SR-2 – ADVISORY STAFF REPORT (5-08-2026)

ADDRESS: 892 W. BOSTON BOULEVARD (EDWARD FISHER RESIDENCE)

APPLICATION NUMBER: HDC2026-00193

SCOPE: INSTALL LANDSCAPING AND HARDSCAPING, CONSTRUCT POOL

Upper Terrace

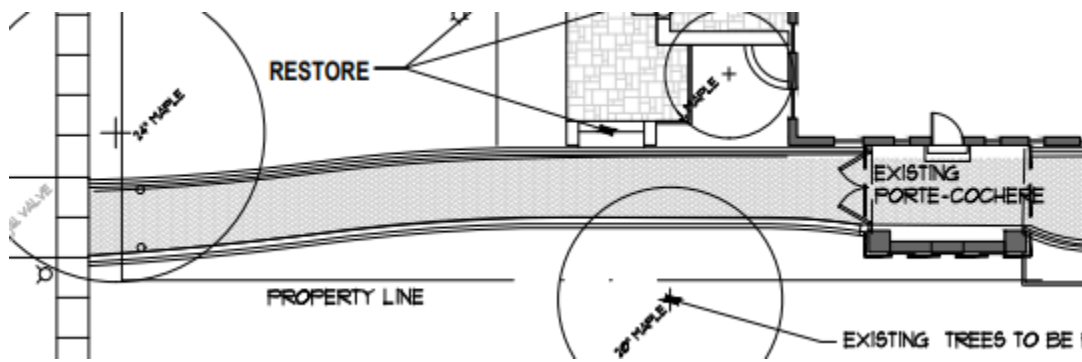
1. The active ingredient in the proposed masonry cleaner is not provided. A test patch will be necessary.
2. A photo of cleaned stone pavers next to proposed replacement paver samples will be needed to confirm color and material match for the pavers before work begins.

Wash and tuckpoint existing upper terrace patio and steps to clean up. Replace missing pieces with matching Buff Tayko pavers.

1. The active chemical in Klenztone and the solution strength/the selected Klenztone product will be submitted to staff and a test patch will be administered before the stone paver cleaning begins.

2. Once a test patch is completed, staff will be provided a photo of clean stone pavers next to the proposed replacement samples for review and approval before paver work begins.

Proposed driveway, from applicant materials. Staff's red arrow indicates the proposed wider drive. The driveway would increase by about 5'8".

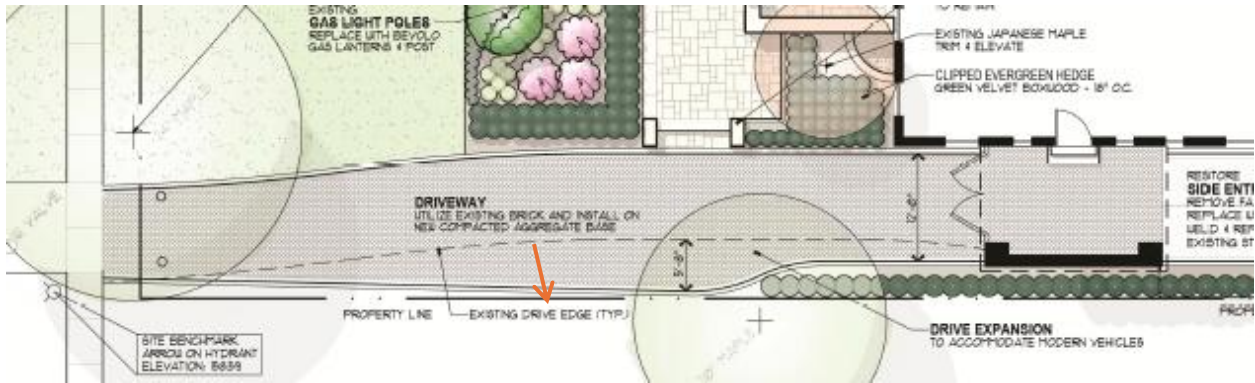
3. Any mortar used in the stone repairs needs to match the historic mortar and be softer than the stone.
4. The proposed expansion of the driveway at the front of the house from the sidewalk (where it is currently 9'6" wide) to its proposed widest point (about 15' 2") would substantially alter the historic expression.

- Proposed is that the drive will remain the same width where it meets the sidewalk (approximately 9' 6"), but instead of the east edge of the drive jogging slightly westward, that curve will be flattened and pushed to the east so that the east edge of the drive will be along the east property line and the driveway will gain 5'8" about a third of the way up the drive and continue at that width almost to the porte cochere.

- Most of the driveways on W. Boston between Hamilton and Third are between 8 and 10 feet wide at the sidewalk. Staff measured the widths (at the sidewalk) of 12 nearby driveways on both sides of W. Boston between Hamilton and Third. Seven driveways (of 12 measured) were between 8 and 10 feet wide at the sidewalk, four drives were between 11 and 13 feet wide, and one (the driveway next to 892) measured 16 feet wide. (The non-contributing, 1960s house at the southeast corner of Hamilton and West Boston has a very suburban form with a wide, modern subdivision-type driveway that is atypical for the neighborhood, and it was excluded from this driveway study.) 892 W. Boston Boulevard's current driveway width at 9' 6" wide is average for the block, and widening it to approximately 15' 2" would make it the second-widest on this block. Additionally, it would widen the drive along much of its visible length (next to the front yard) by about 40%.

- Staff analysis:** Boston-Edison's Elements of Style Element 13 states that "Straight side driveways leading from the street to rear garages are the norm..." and that "These driveways are paved in asphalt, concrete, or brick." The brick driveway is a historic, character-defining feature of the property and it relates historically and functionally to the porte cochere. While the drive is proposed to remain its historic width at its base at the sidewalk, for much of the rest of the visible, front-yard portion of the driveway, it would be 40% wider than the historic width, wider than almost every other driveway on the block, and wider than the porte cochere for much of its length. (Near the porte cochere, the drive would reduce so that the driveway's eastern edge would curve back toward the porte cochere to meet its easternmost columns.) It is staff's opinion that the driveway could be slightly widened and still be compatible and proportional, but it is staff's opinion that the current proposal expands the driveway too much. As Standard 9 states, "The new work shall be...compatible with the massing, size, scale, and architectural features to protect the integrity of the property and its environment." It is staff's opinion that the proposed driveway expansion along the front lawn is wider than would be compatible.

3. Any mortar used in the stone repairs needs to match historic mortar and be softer than the stone.
4. The driveway at the front of the house will be expanded by less than the proposed 5'8". The widened driveway will be no wider than 9' 6" at the sidewalk and 12' along its length and at the porte cochere.

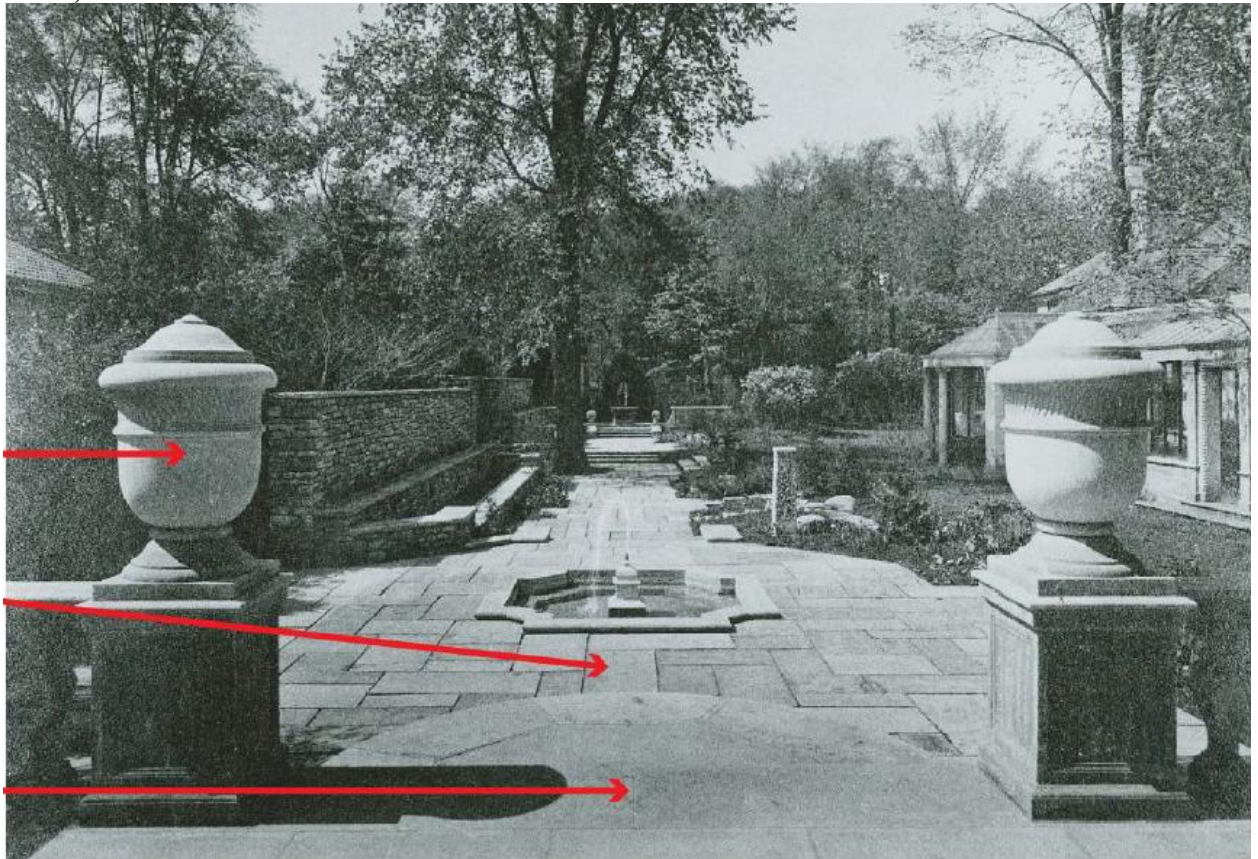
5. The service court bricks are historic, character-defining features and their removal would diminish the property's historic character.
6. Dimensioned drawings for the south fountain's water feature have not been included in the proposal.

- **Rear yard, transition terrace: Remove concrete and brick pavers and replace with natural stone pavers. Remove existing fountain sculpture and bowl from existing fountain and replace with replicated limestone fountain (south water feature) from historic photos.**

- The transition terrace surrounds the south water feature. The plan from *Architectural Record* shows that this terrace was square with stone pavers surrounding the octagonal fountain. An octagonal-shaped terrace with brick pavers replaced the square stone terrace at some point (staff could not determine when). Proposed is to keep the octagonal shape for the new terrace but to use stone pavers like the original terrace. The original water feature was carved limestone, and the proposal is to re-create that feature of limestone. Currently, the fountain includes a cast sculpture and bowl. The concrete basin also needs to be repaired and restored. The cracks of the basin are proposed to be filled, the surface is to be waterproofed, and the bottom of the basin would receive a pebble interior finish. The new water feature would be installed and the entire fountain would be restored to working order. (Page 41 of the application PDF includes a fountain restoration scope of work.)

6. Dimensioned drawings for the south fountain will be submitted to staff and approved before work begins.
7. Dimensions of the current and proposed service court wall will be provided to staff, and a clear photo of the sample replacement material against the existing material will be provided to staff before work begins.

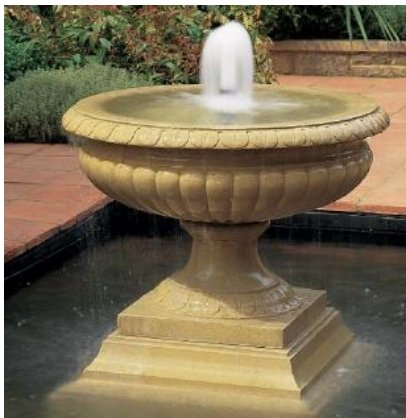
- Historic photos show a simple, shallow bowl for the fountain, in contrast to the rounded and patterned Haddonstone bowl that has been specified in the application.

- **Staff analysis:** The careful repairing and restoration of the concrete basins of the fountains so that they are returned to their historic appearance meets the Secretary of the Interior's Standards for Rehabilitation, since historic materials are being repaired and not replaced. It is important that the waterproofing methods proposed for the basins will preserve the concrete over the long term and will not change the concrete basins' color or design. For the north fountain, preserving and repairing the historic base (as proposed) meets the Standards and Guidelines. The proposed replacement bowl does not match the shallower, flatter historic bowl, but is more like the shape of the current (replaced) bowl with more ornamentation. Since the existing bowl is not historic, the Standards allow it to be replaced and require that the replacement is compatible. Assuming that the bowl will properly fit the lions base, staff finds the bowl compatible with the base.
